# ST LEONARDS SOUTH MEETING 1 – 25th February 2022

<b>Applicant:</b>	GYDE Consulting		
<b>Contact:</b>	<a href="mailto:stephenk@gyde.com.au">stephenk@gyde.com.au</a>		
<b>Property:</b>	11-19 Holdsworth Avenue and 10-20 Berry Road St. Leonards		
<b>Owner:</b>	<b>Aqualand</b>		
<b>SLS Area:</b>	<b>AREA 16 and 17</b>		
<b>SLS Area Map:</b>			
<b>Site Area:</b>	Area 16: 2766 sqm. Area 17: 2229 sqm. <b>TOTAL: 4995 sqm</b>  <b>(Total Site area referred to as 5015 sqm in Cover Letter by GYDE and Existing Plan by Silvester Fuller)</b>		
<b>Zoning:</b>	R4 High Density Residential		
<b>Description of Proposal:</b>	Construction of two (2) RFB buildings with 129 apartments and with 4 basement parking levels (178 car spaces), green spine, child care facility, communal area, delivery of part of east/west road link.		
<b>Plans/ Documents Submitted:</b>	<b>Description</b>	<b>Author</b>	<b>Date</b>
	PRE DA -Cover Letter	GYDE Consulting	04/02/22
	Apartment Type Summary Book	Silvester Fuller	17/12/21

Attendance Record	<b>Council Staff Attending either at the DRP Meeting or Pre-DA Meeting (In Addition to DRP)</b>		
	<b>Name</b>	<b>Position</b>	
	Mark Brisby	Executive Manager – Environmental Services

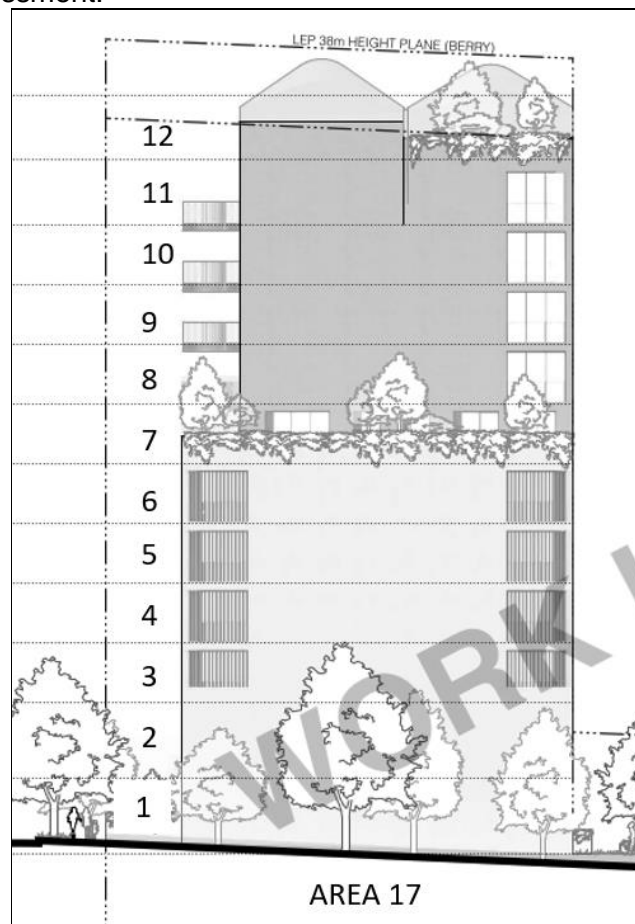
Areas 16 and 17 are subject to 10-storey height controls.

Area 17 appears to be 12-storeys in height and does not comply  
Area 16 appears to be 11-storeys in height and does not comply. Refer to figures 1

The proposed lower levels of the building are not considered to be part storeys as the areas of excavation do not relate to a significantly sloped site nor do they exclusively relate to basement carparking that partially protrudes above natural ground level.

**Figure 3:** Non-compliant setbacks from east/west link. (East Elevation)

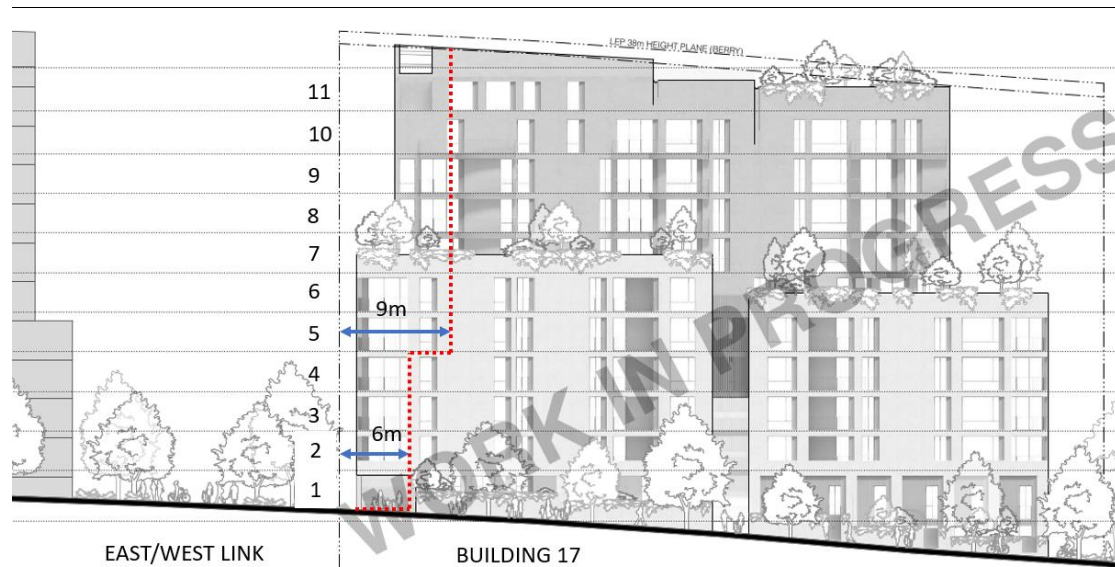
Please refer to Figure 3 below detailing the non-compliant setbacks. The proposal should be amended to comply with the required setbacks in the DCP.

DRP *"The additional GFA proposed to the North elevation of the Berry building is not supported as in addition to the non-compliant setbacks this negatively impacts the design and amenity of the childcare centre and ground plane. Consider the extension of the "secret gardens" to the north elevation, with landscaped terraces rising to the east-west pedestrian link, thereby allowing improved solar access, outlook and street legibility to the childcare centre. Consider also the reconfiguration of the indoor*

community space to the north-west corner adjacent to the street corner to enable direct level access and address to Berry Road”.

**Figure 4:** Soil Plan (left) and Courtyard level plan (right)

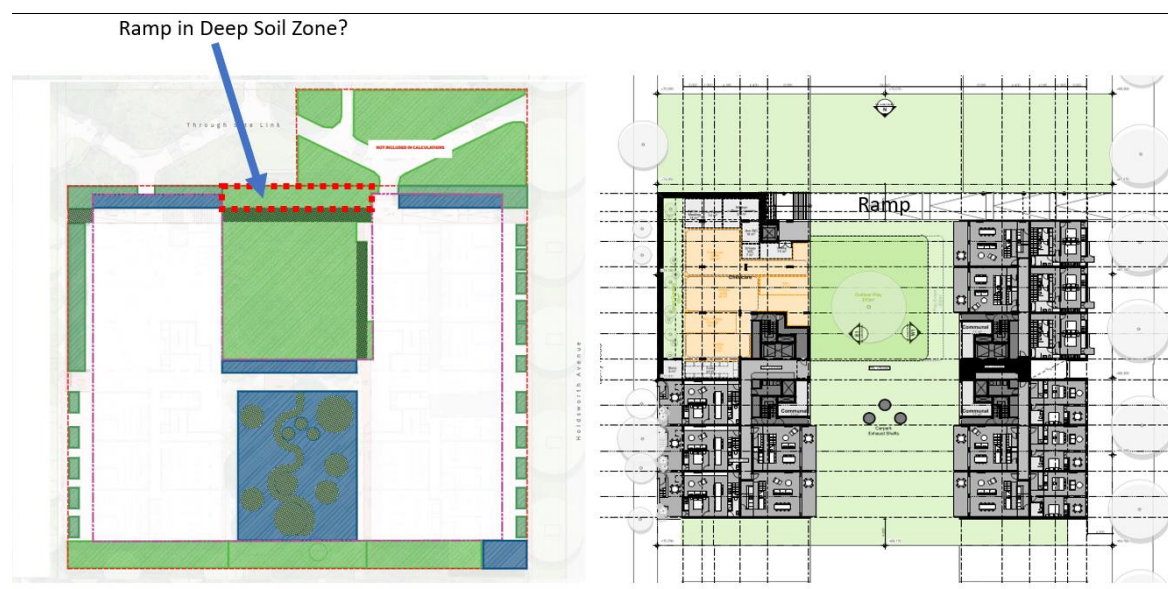
- Section 3.8 of The Landscaping Report indicates a total Deep Soil Calculation of 754 sqm. This equates to 51.4% of green spine area of 1463 sqm.
- However, the deep soil zone calculation appears to include the ramp adjacent to the east west link. (see figure 4)
- A desktop assessment removing this ramp area of approximately 108sqm Council shows deep soil within green spine is approximately 648 sqm in area. This would equate to 44% of deep spine and **would not comply**.

- Any proposed basement carparking should be predominantly be confined to below the buildings above and significant encroachments are **prohibited** from compromising the Green Spine Area.
- Further details should be submitted including calculation of the total area of unencumbered deep soil in sqm, and calculation of total green spine area.

- As per the SLS Landscape Masterplan: All basement must go down two levels (underneath building footprint) before intruding into Green Spine, not one:- *'Intrusions into deep-soil Green Spine areas shall only be considered after two levels of basement parking has been provided under the building footprint.'* Intrusions after two levels are to be minor. As no sections of the basement carparking have been submitted it is difficult to ascertain if the intrusion into the green spine comply.
- Refer to landscaping comments for further details.
